REVISED NOTICE OF DECISION

1951 Schurman Warehouse and Office

Land Use Application Nos.:	SPR 22-004 (Site Plan Review – Type 2) SEP 22-004 (SEPA)
Applicant:	Wilson Architects PLLC C/O Rusty Muyuela 404 E. 15 th St #7 Vancouver, Washington, 98663
Property Owner:	DT Realty LLC Mark Dawkins 610 NW 16 th Cir Ridgefield, WA, 98642
Site Location:	1951 Schurman Way Woodland, WA 98674
Parcel & Size:	507870102, 3.06 Acres
Zoning Designation:	Light Industrial, I-1
Date Application Received:	October 28 th , 2021
Notice of Application & Likely DNS issued:	Revised: May 11 th , 2022 Original: April 28 th , 2022 [See: case # SEP-22-004]
Comment Period & SEPA Appeal Period Ended:	Revised: May 25 th , 2022 Original: May 12 th , 2022
Notice of Decision Issued:	Revised/Final: June 3 rd , 2022 Revised: June 1 st , 2022 Original: May 31 st , 2022
DRC Decision:	Approve with Conditions

STABILIZED CONSTRUCTION ENTRANCE						E-05
APPROVED	REVISIONS	DATE	DRAWN	DESIGNED

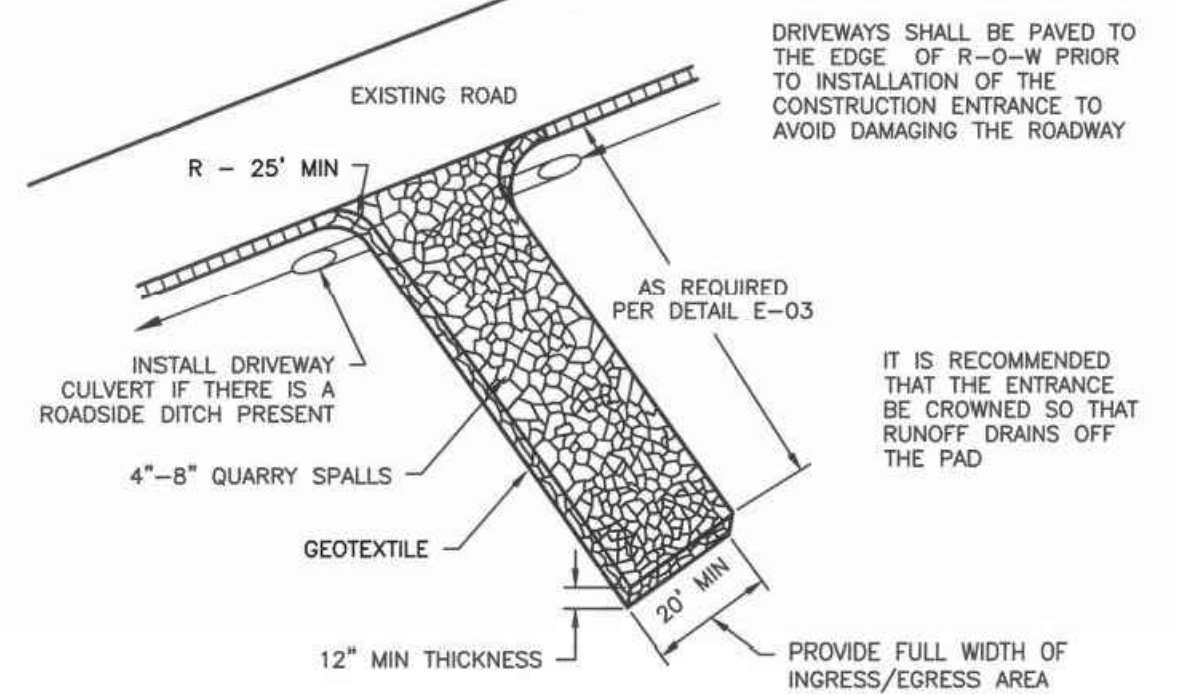
Finding 13B: Construction Entrance meets the width requirements as defined within City of Woodland Std. Details E-03 and E-05 but not the length requirement. The site will have more than one-acre exposed soil and the Construction Entrance shall be 100-foot minimum length. Please revise this sheet to show a minimum 20-foot wide by 100-foot-long Construction Entrance. (See condition 11)

11. Revise the proposed construction entrance as directed to ensure accordance with WMC.
12. A Final Stormwater Technical Information Report (TIR) is required that complies with WMC 15.12 and the 1992 Stormwater Management Manual for the Puget Sound Basin as adopted by the City of Woodland and addresses the following concerns:

South Biofiltration Swale Typical Section
NTS

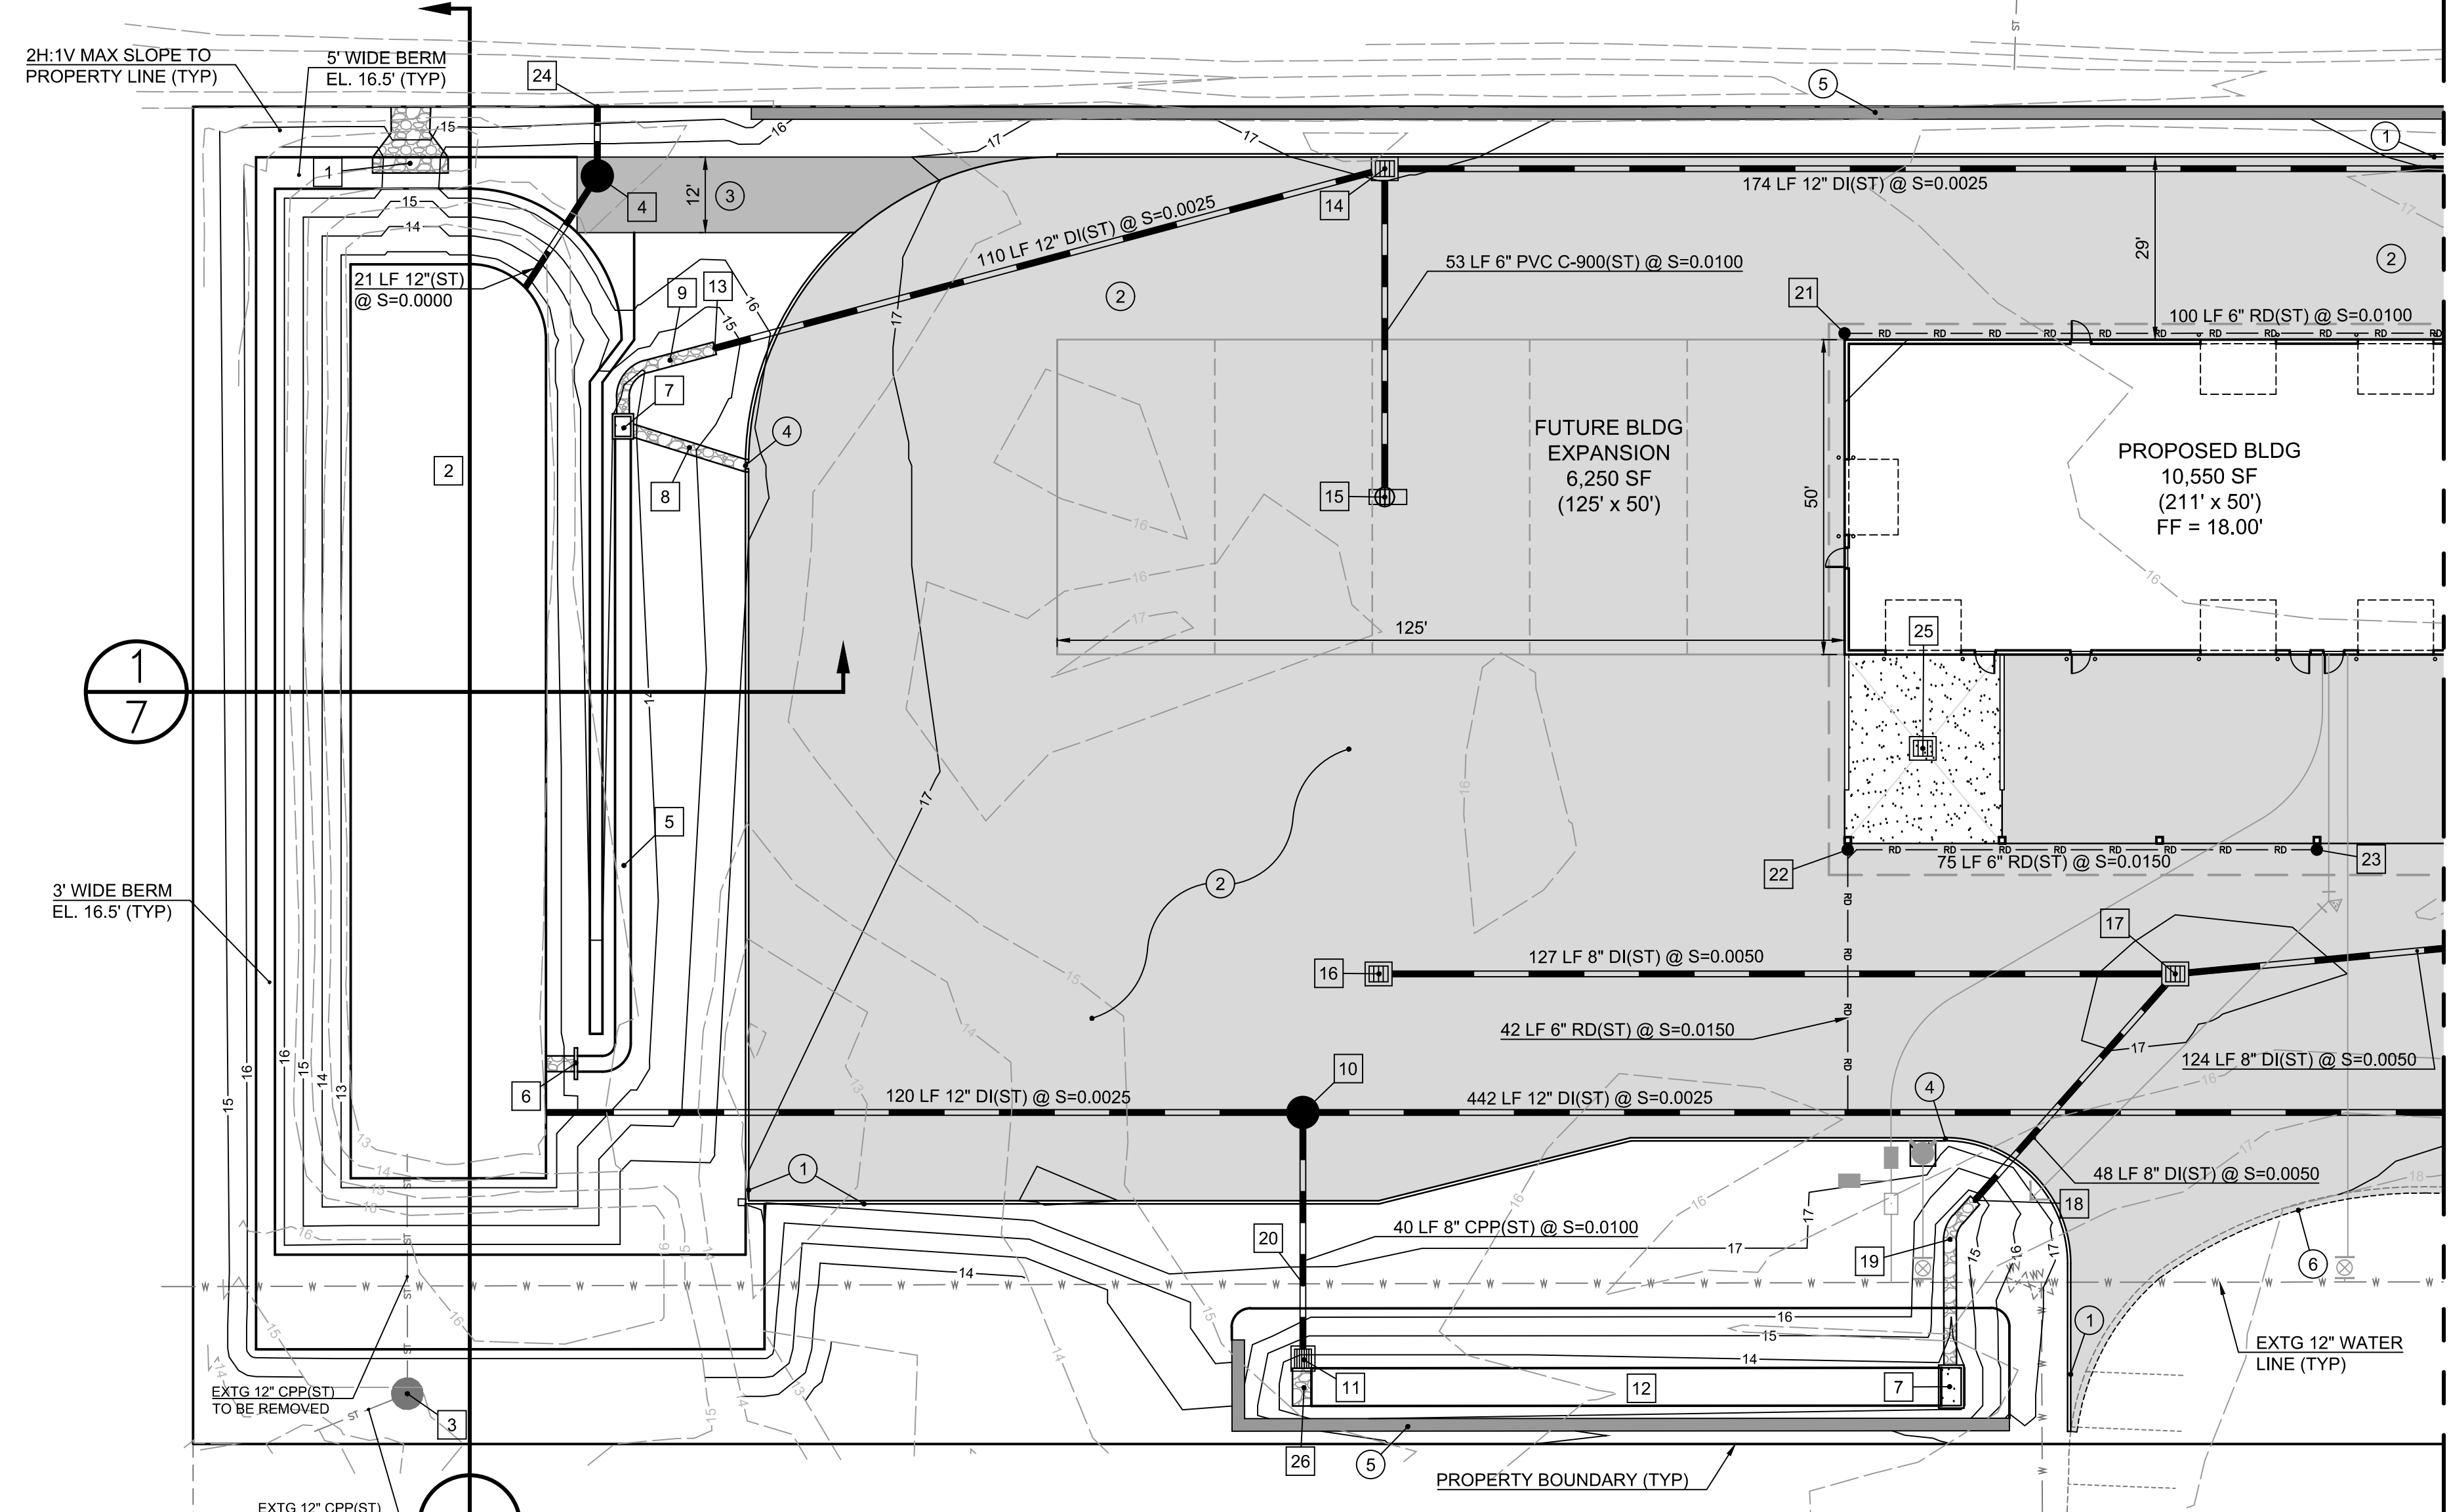
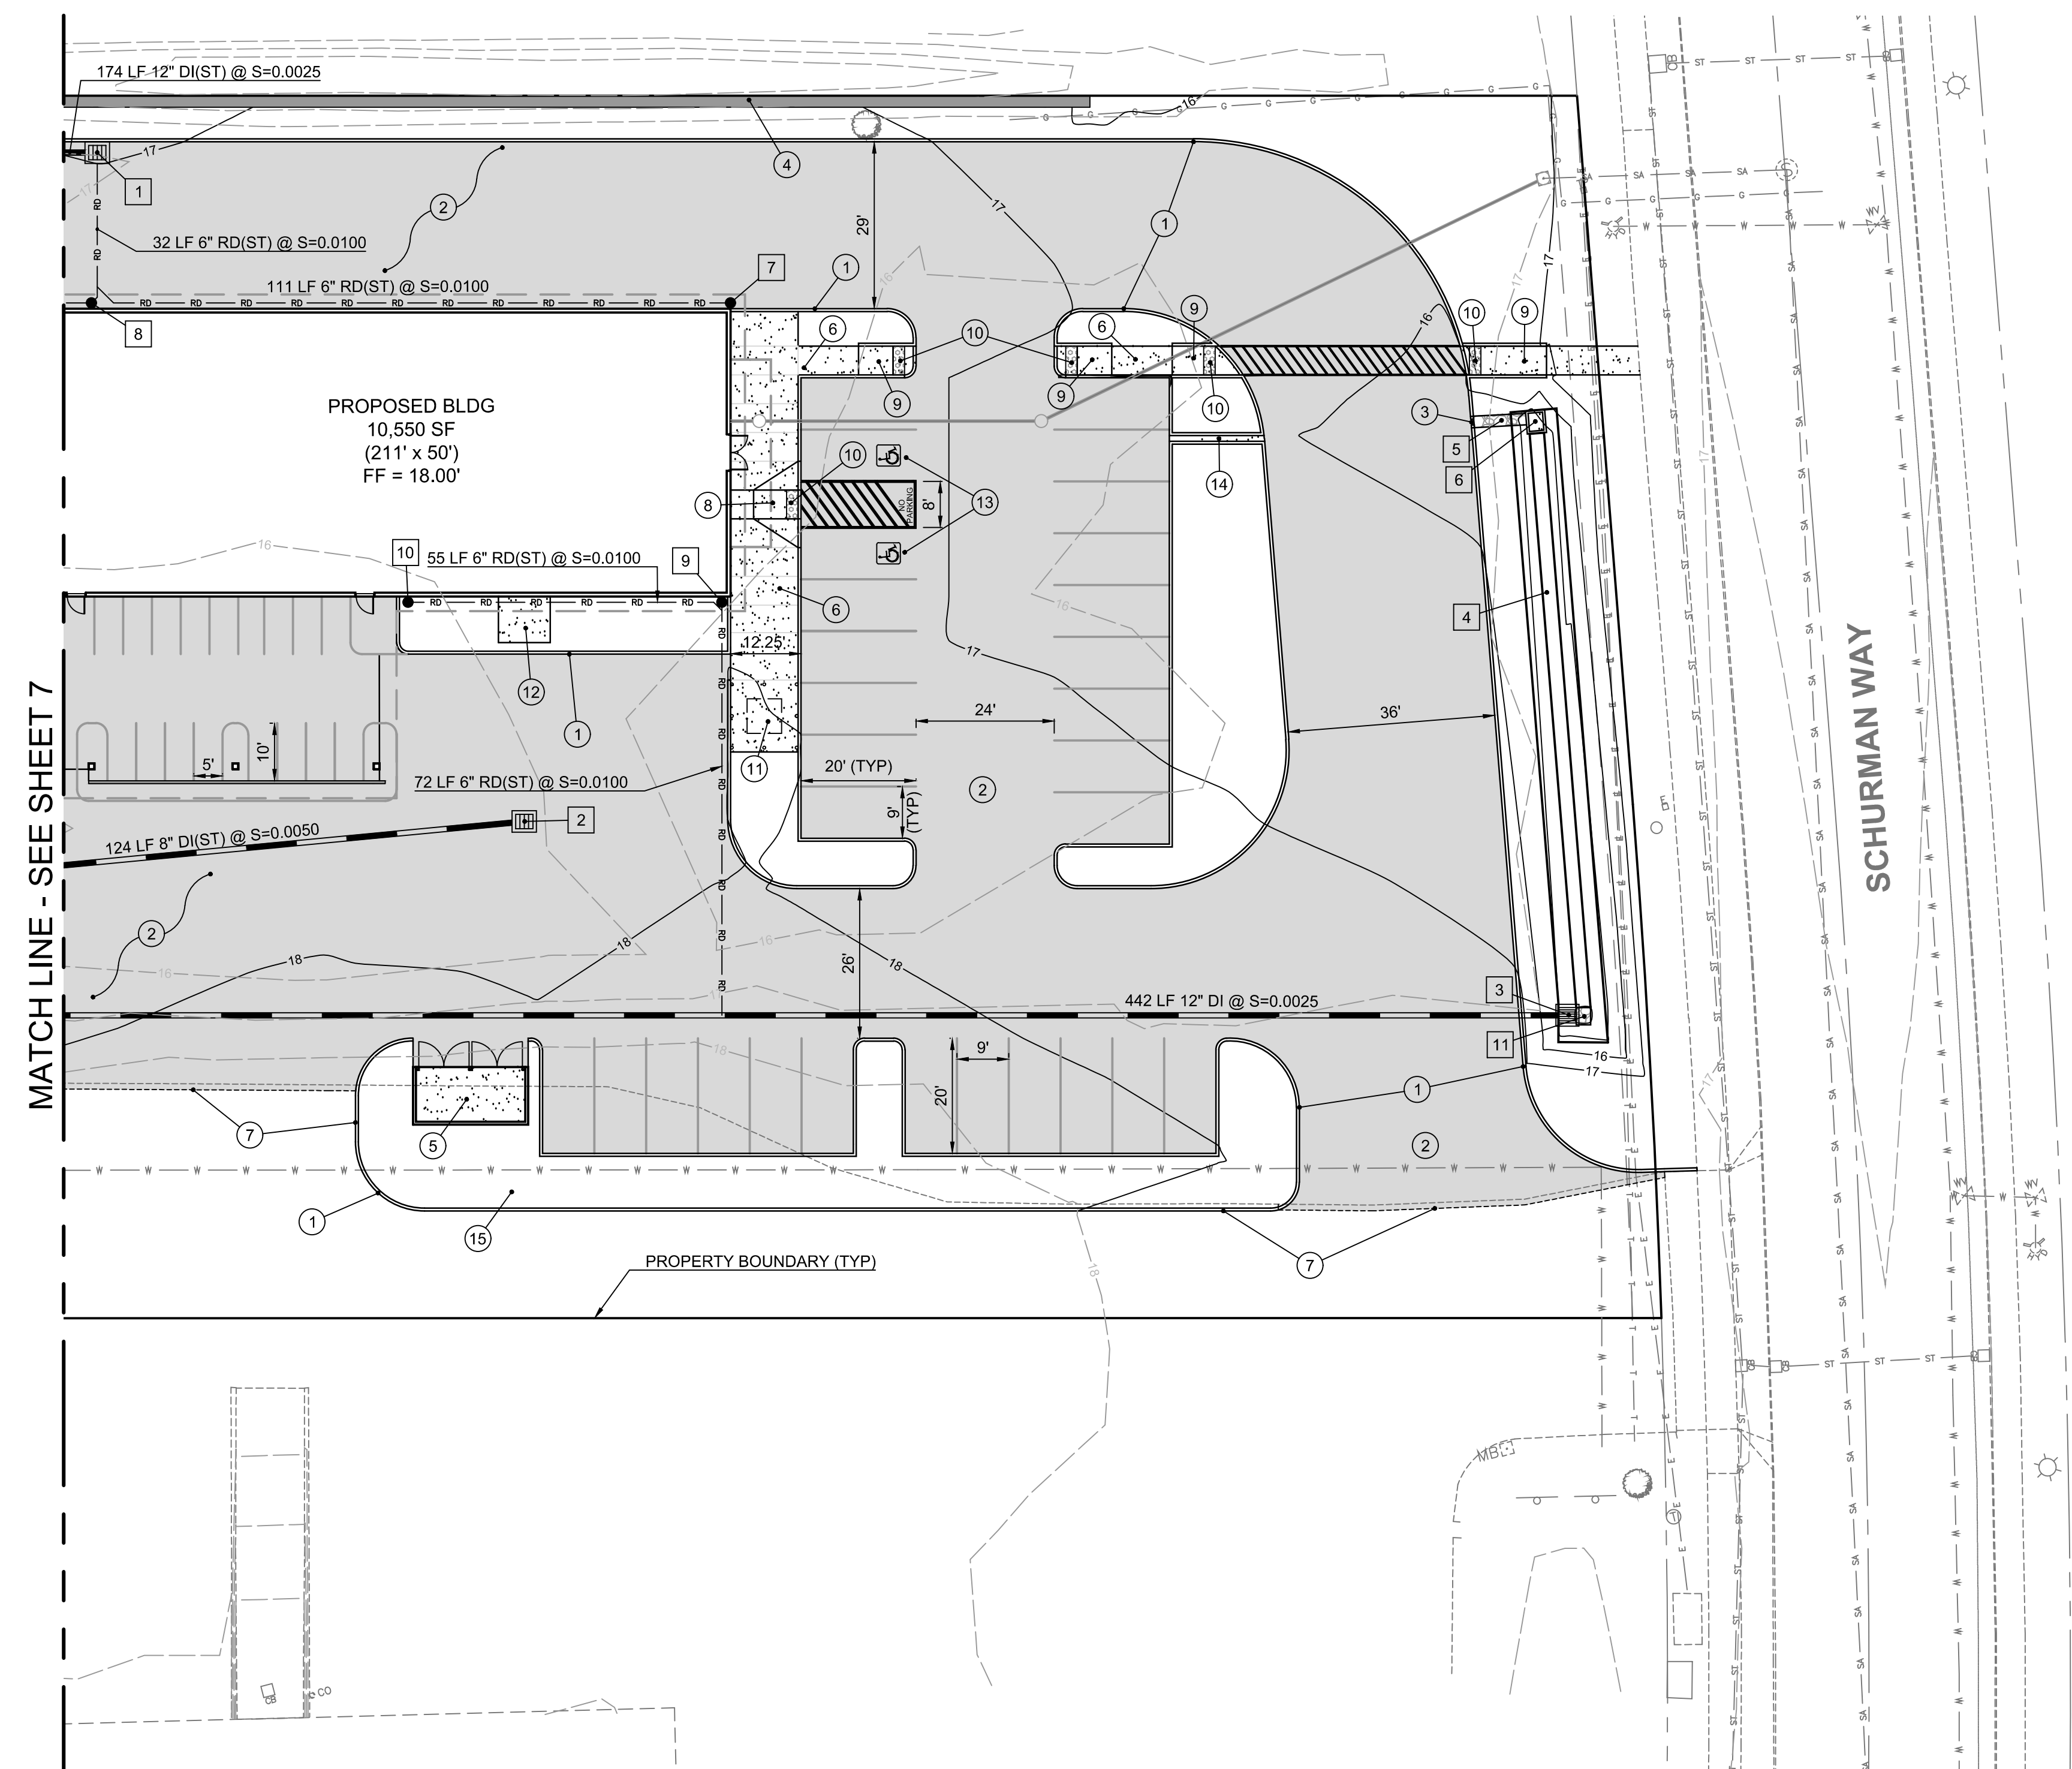
Finding 14B: The applicant's submittal included a final stormwater TIR. A condition of approval is added to submit a revised, final stormwater TIR to address the following concerns:

1. Woodland MC 15.12.080, Quantity Control, requires 2-, 10-, 25- and 100-year, 24-hour storm events. 25-year not included.
 - a. Add 25-year, 24-hour storm values to Table 1 and Table 2.
2. Bioswale 11R, model lists 2.5' width at bottom, plans show 2'.
 - a. Revise the HydroCAD model for 2-foot-wide swale bottom or revise plans to show 2.5-foot-wide swale bottom.
3. Per Appendix III-6.1 of the 1992 Puget Sound Manual, biofiltration swales with less than 2-percent slope should include underdrains.
 - a. Provide under drains for the biofiltration swales.

- a. Add 25-year, 24-hour storm values to Table 1 and Table 2.
 - b. Revise the HydroCAD model for 2-foot-wide swale bottom or revise plans to show 2.5-foot-wide swale bottom.

- c. Provide under drains for the biofiltration swales.
- 12b. Final TIR submitted must continue to demonstrate that stormwater flows released off this property shall not be increased because of the proposed development from its current (undeveloped) state.
